420 SAN MATEO BLVD. 87108

THE PROJECT IS TO CONSTRUCT A TANNING SALON

TITLE DRAINAGE & GRADING PLAN
ALOHA TANNING

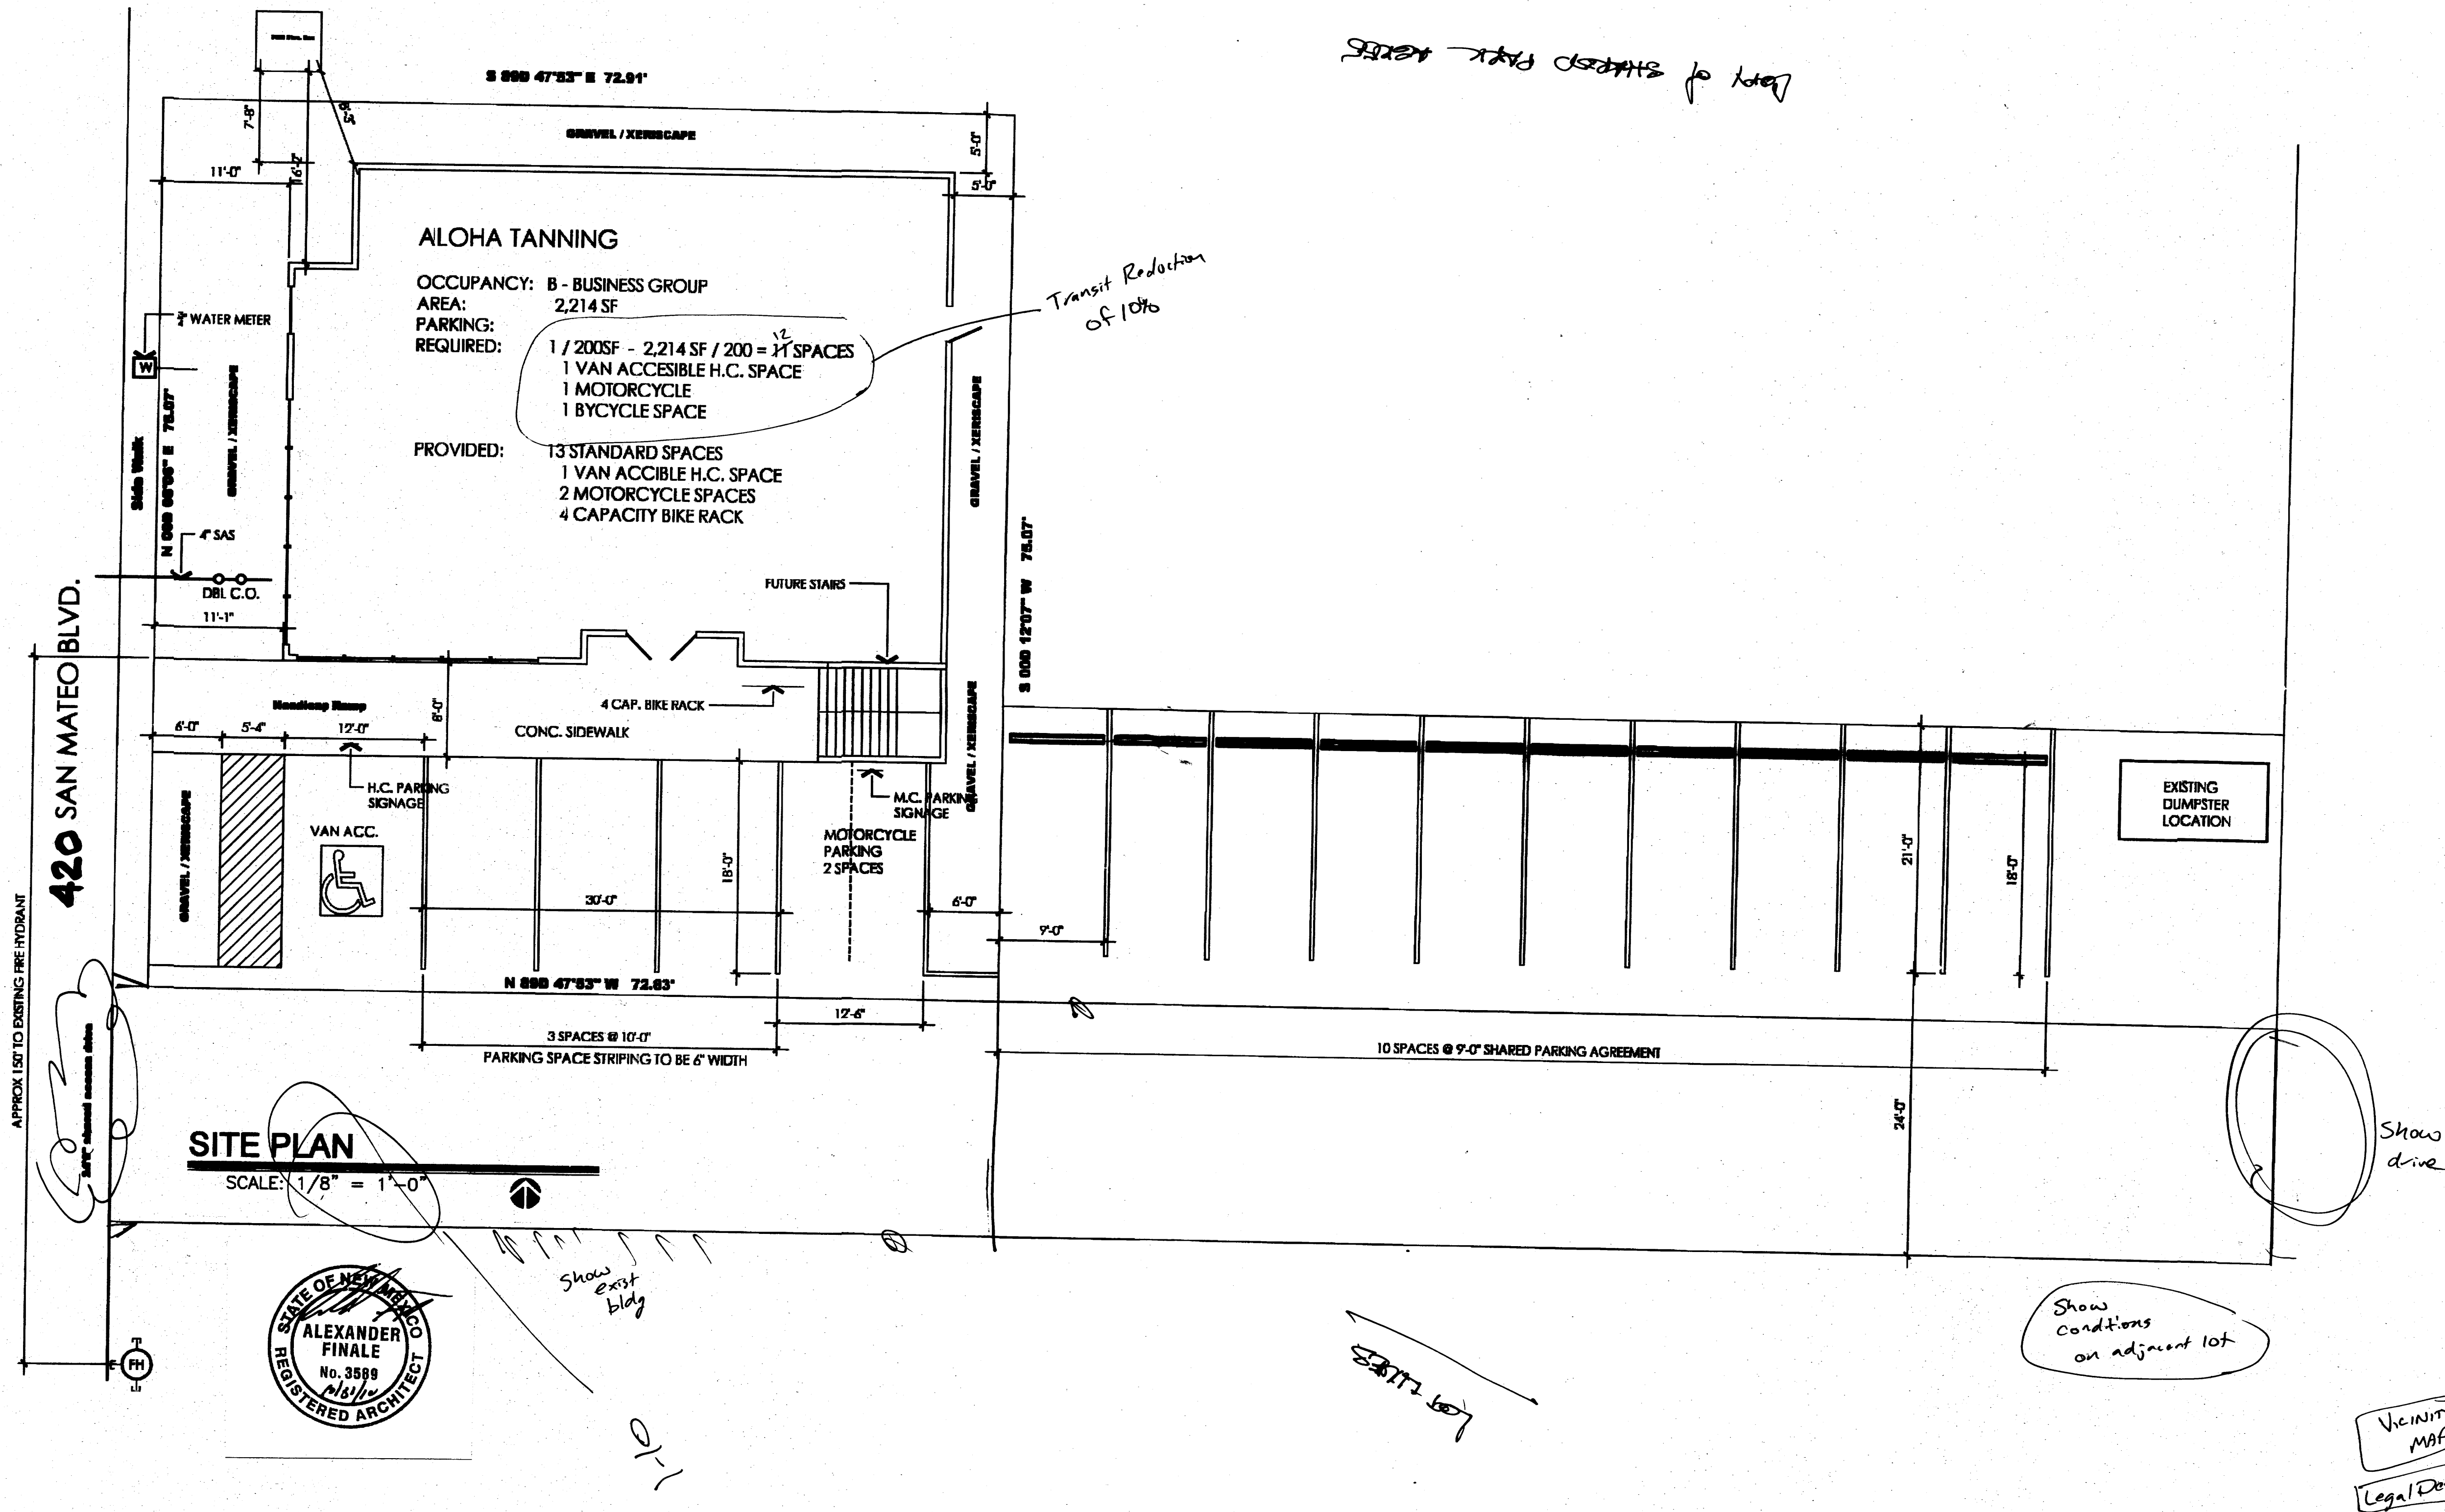
Parking Calculations
 Vicinity Map
 Legal Desc.
 Aerial Photo indicates access is shared w/ adjacent lots
 - show how this is accomplished
 (need to show at least part of adj. lots)
 - provide copy of access easement
